# Economic and Social Council

#### Working Party on Lighting and Light-Signalling

## Report of the Working Party on Lighting and Light-Signalling on its sixty-ninth session (8-11 April 2013)

ANNEX 3  
EXAMPLE OF THE ARRANGEMENT OF THE APPROVAL MARK  
(see paragraph 2.4.3)

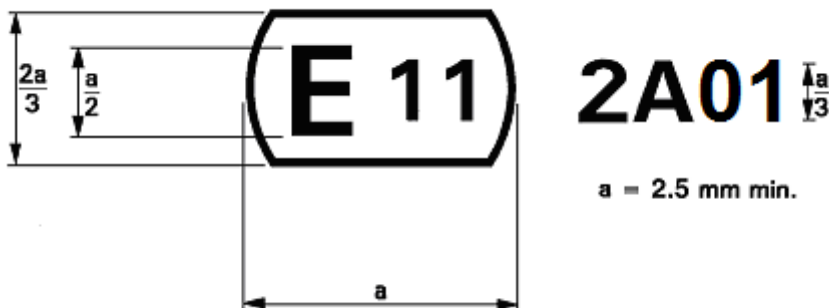
51. The expert from Germany introduced GRE-69-11 proposing to extend the range of possible combinations for identification codes into Regulation No 37. GRE adopted this proposal as reproduced below and requested the secretariat to submit it to WP.29 and AC.1 for consideration at their November 2013 sessions as draft to Supplement 42 to Regulation No 37.

Annex 3, amend to read:

"2.4.2. This will be followed by an identification code comprising not more than **three** characters. Only the Arabic numerals and capital letters listed in footnote 3 shall be used ..."

"ANNEX 3  
EXAMPLE OF THE ARRANGEMENT OF THE APPROVAL MARK  
(see paragraph 2.4.4)

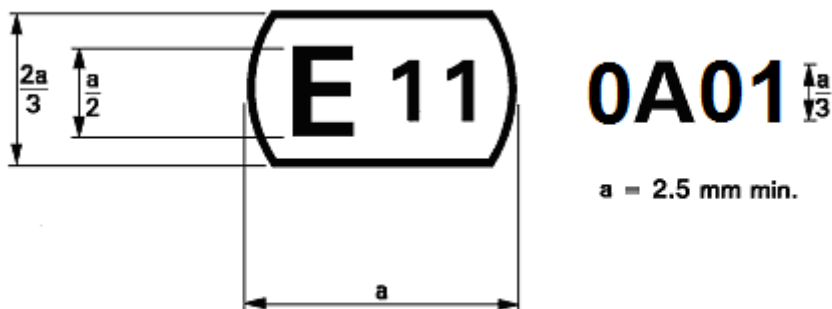
52. The expert from Germany introduced GRE-69-12 proposing to extend the range of possible combinations for identification codes into Regulation No 99. GRE adopted this proposal as reproduced below and requested the secretariat to submit it to WP.29 and AC.1

*Annex 3*, amend to read:

"2.4.2. ... This will be followed by an identification code comprising not more than **three** characters. Only the Arabic numerals and capital letters listed in footnote 1 shall be used."

The above approval mark affixed to a gas-discharge light source indicates that the light source has been approved in the United Kingdom (E11) under the approval code 0A01. The first character of the approval code indicates that the approval was granted in accordance with the requirements of Regulation No. 99 in its original form."
